3/2010/0025
Amended plans rec'd 10/03/10

Job Title
Proposed Alterations
Hodgsons Barn
Slaidburn Road
Waddington

Drawing Title
Proposed
Plans and Elevations

3965 - 06D

west elevation

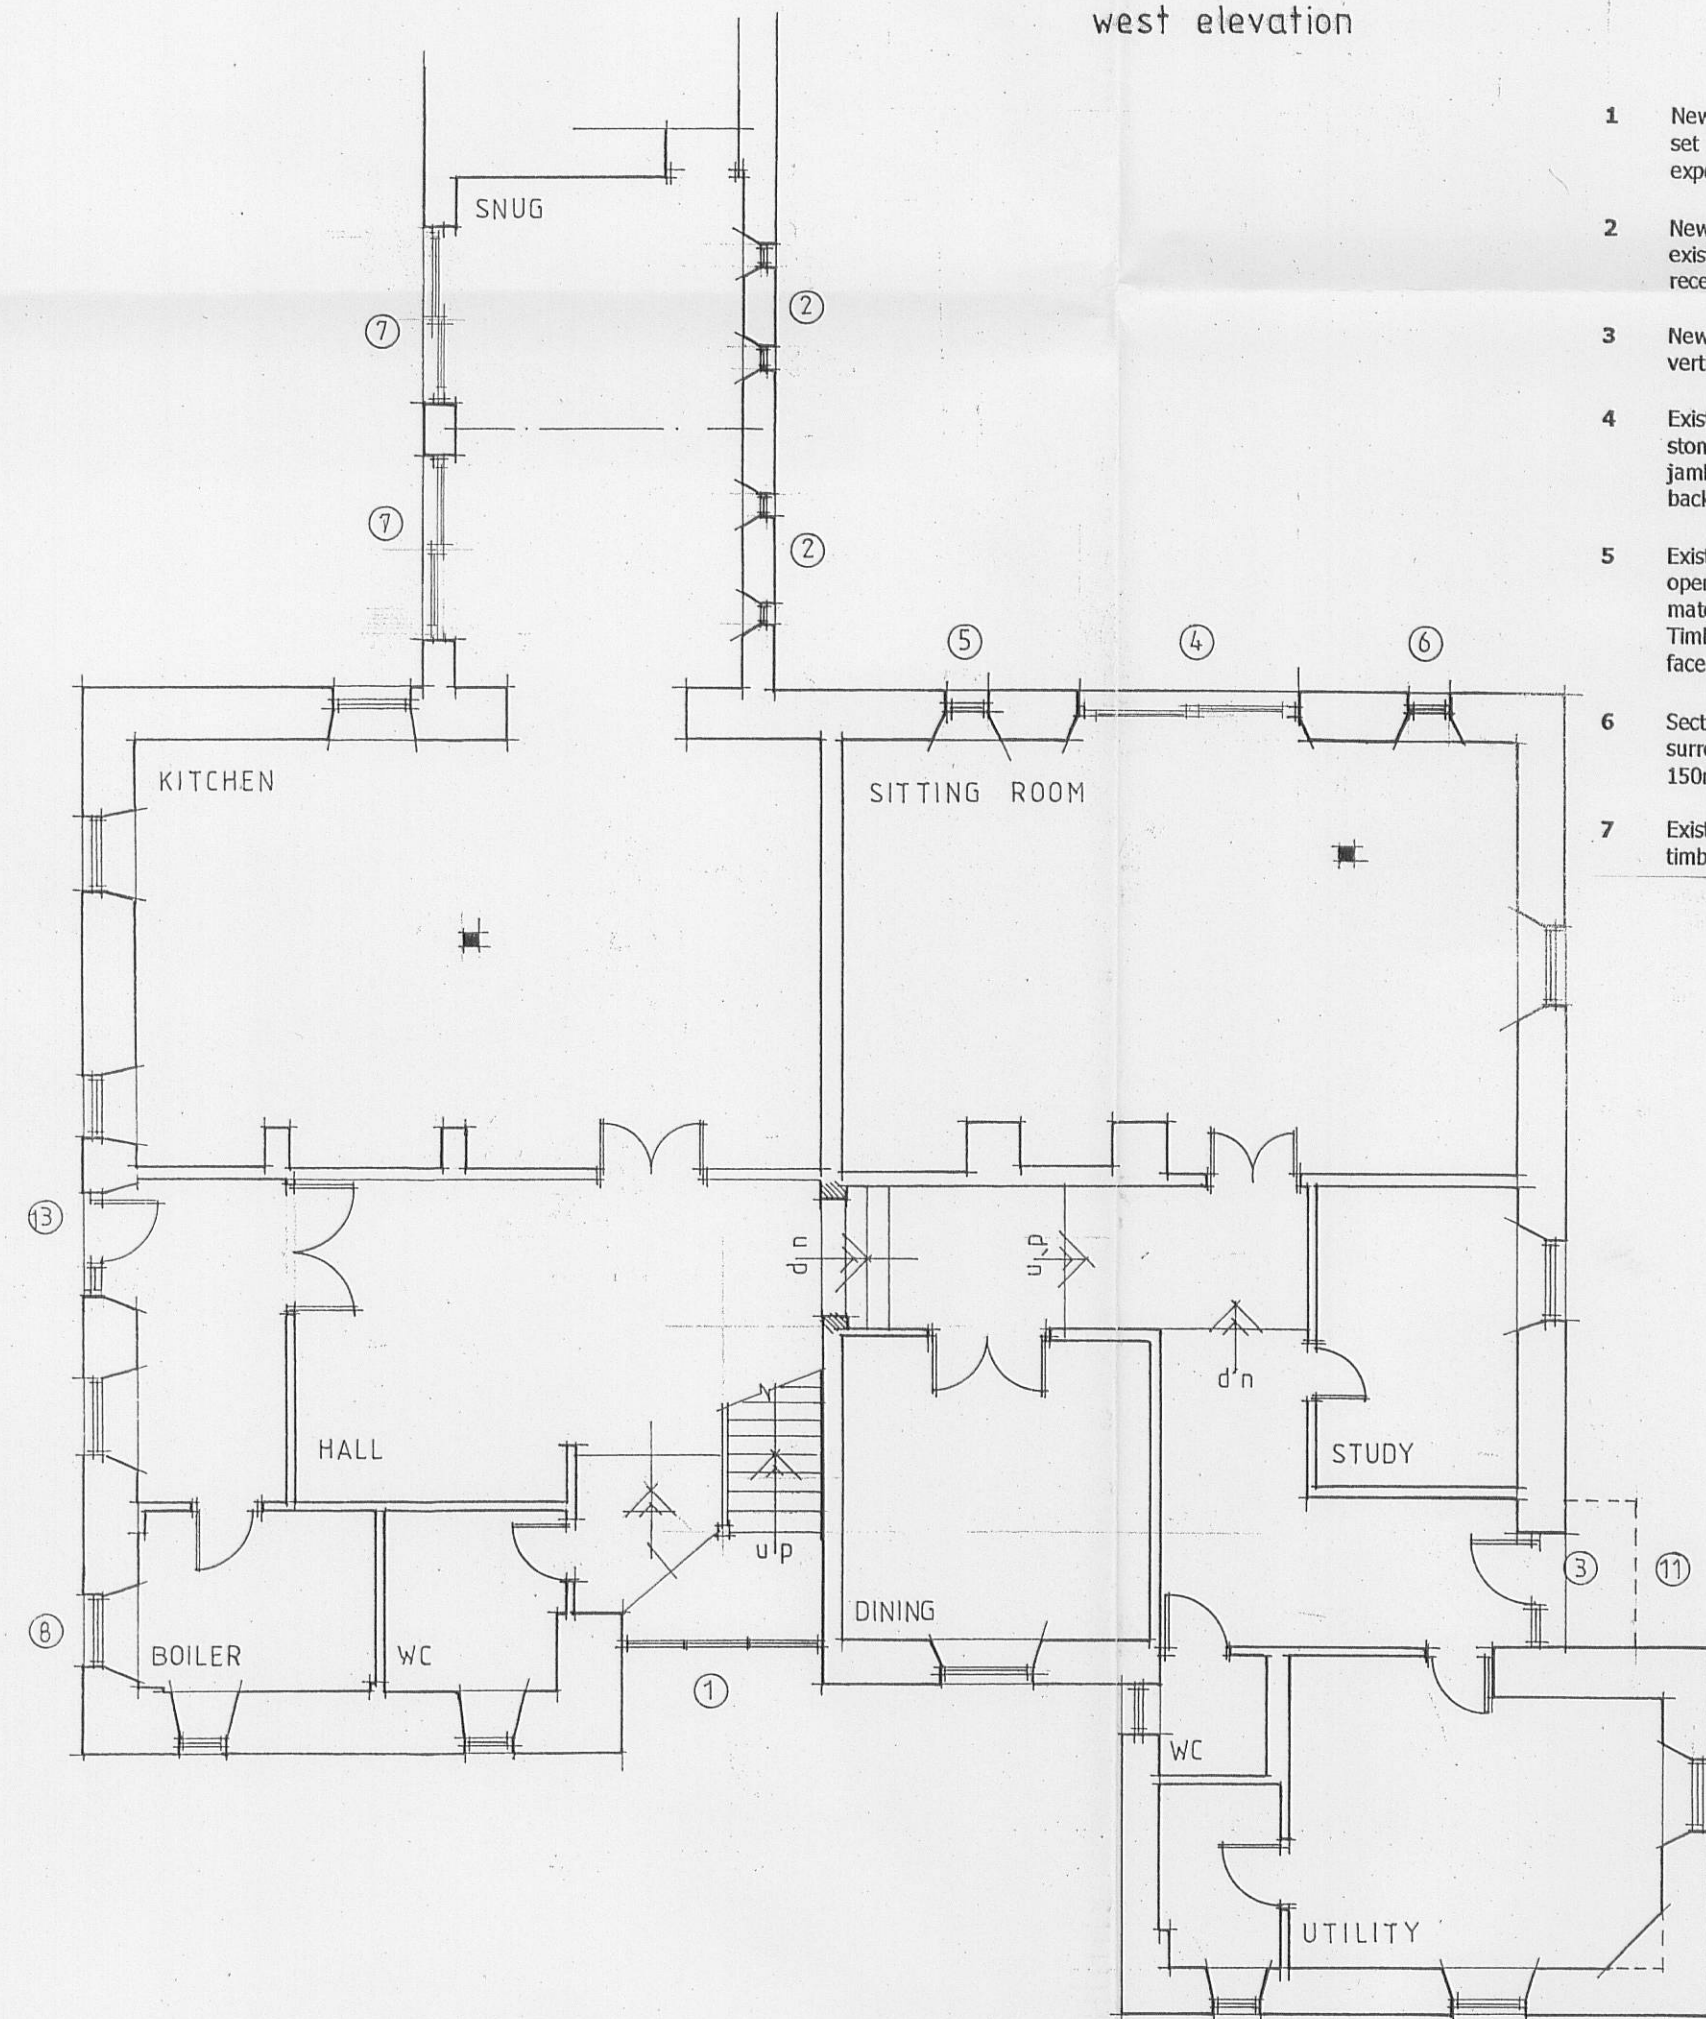
- D Ref window note 8 - ext'g opening part built up within ext'g surrounds. Window note 1 - design amended 10/03/10
- C Canopy ref 14 amended - 3no rooflights to west elevation repositioned - window + door pattern amended 10/12/10
- B Door head to west elevation raised. Side panel and oak / slate canopy added to south elevation 7/1/2010
- A Window opening Ref 12 enlarged 5/1/2010
